**SUBJECT:** **R.E. Ginna Nuclear Power Plant**  
Docket No. 50-244

Response to Request for Information Re: License Amendment Request:  
Emergency Core Cooling System (ECCS) Accumulator Boron Concentration  
Verification Frequency

Figure (1)

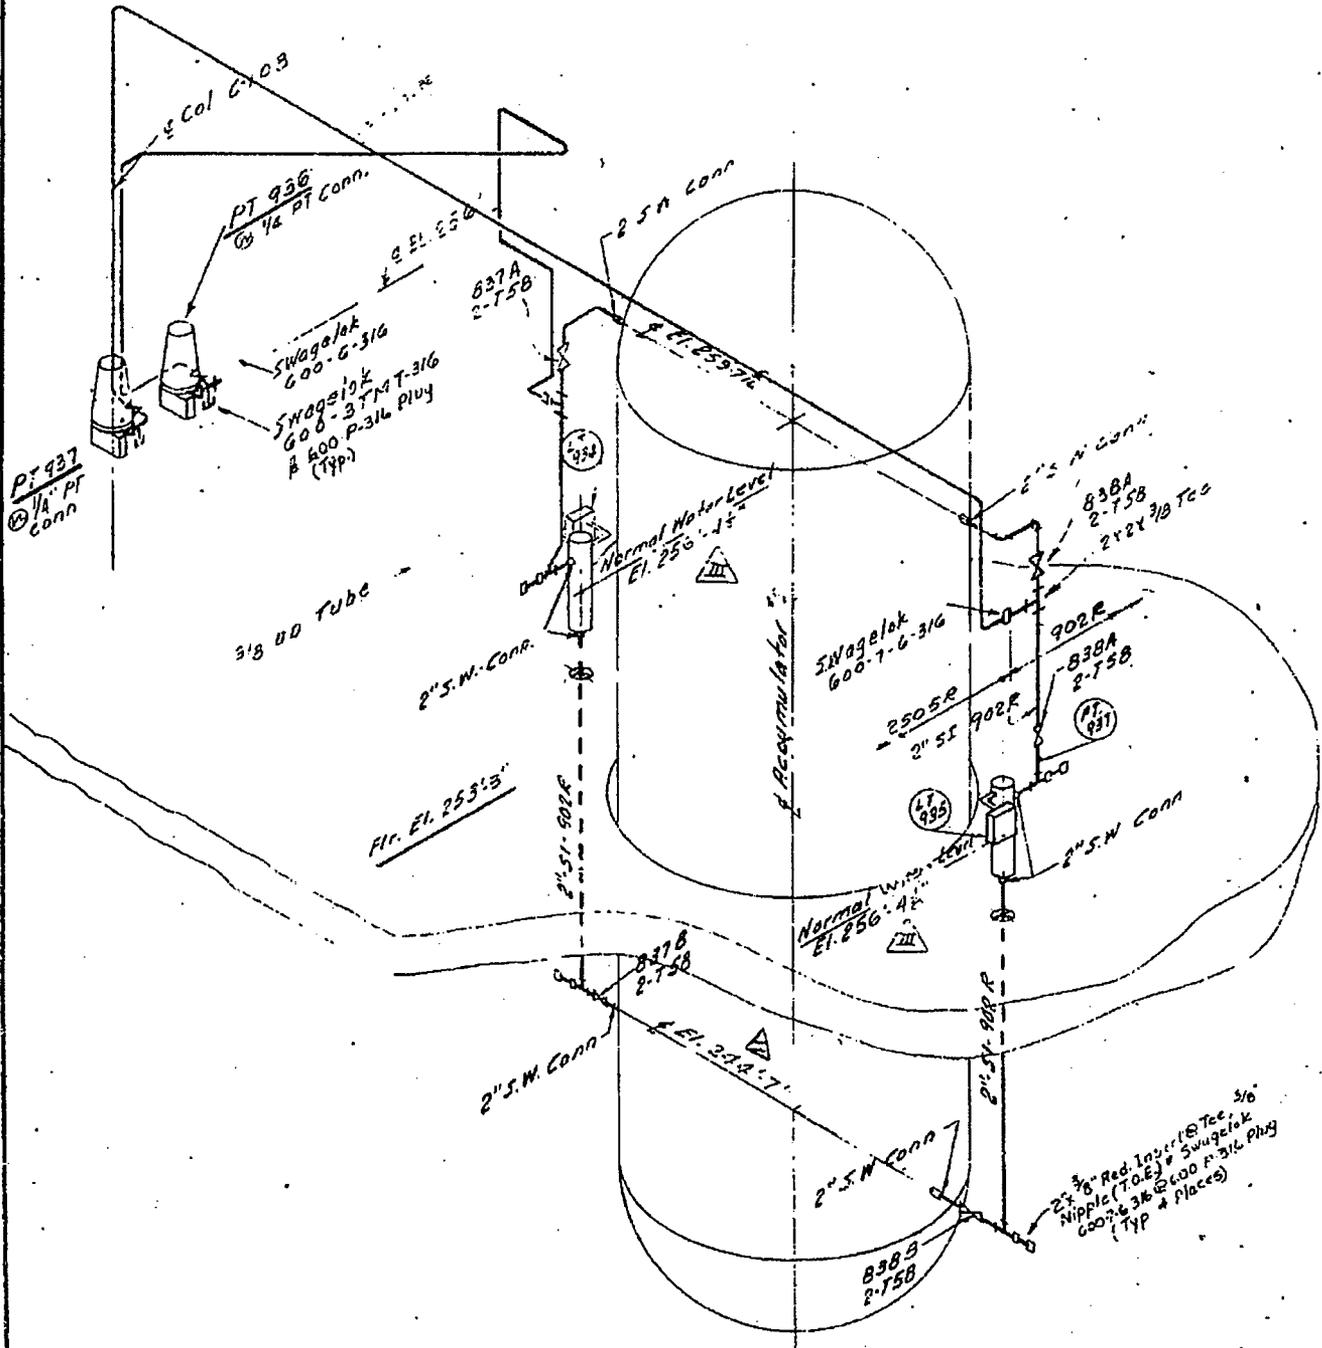
**Question 5: Provide a more detailed description of the level instrumentation and how the instrumentation correlates levels of the liquid in the accumulator to corresponding volumes. In order to understand how the system works, physical arrangements of the different components of the system should be described.**

The attached as built ECCS Accumulator drawing, Figure (1), illustrates the relationship between the level transmitters (LT-934/935) and the ECCS Accumulator. The level transmitters are buoyancy displacer type transmitters and will not begin to indicate until the associated accumulator reaches a level corresponding to the bottom of the sensing unit. The Span of this unit is scaled to 0% - 100% of the 14 inch span of the unit. Whereas, the distance from the bottom instrument tap to normal water level is ~ 141 inches (Reference: Ginna Design Analysis DA-NS-97-051, Calculation of SI Accumulator Water Level as a Function of Water Level

Indication). Therefore, this could be considered a narrow range instrument, which provides increased sensitivity to detect inleakage.

Using the above information, the top and bottom of the scale would correspond to the following volumes.

$$8311 \text{ gal}/50\% \text{ level} - (50\% * 6.25 \text{ gal}/\%) = \sim 7998.5 \text{ gal at } 0\% \text{ level}$$

$$8311 \text{ gal}/50\% \text{ level} + (50\% * 6.25 \text{ gal}/\%) = \sim 8623.5 \text{ gal at } 100\% \text{ level}$$
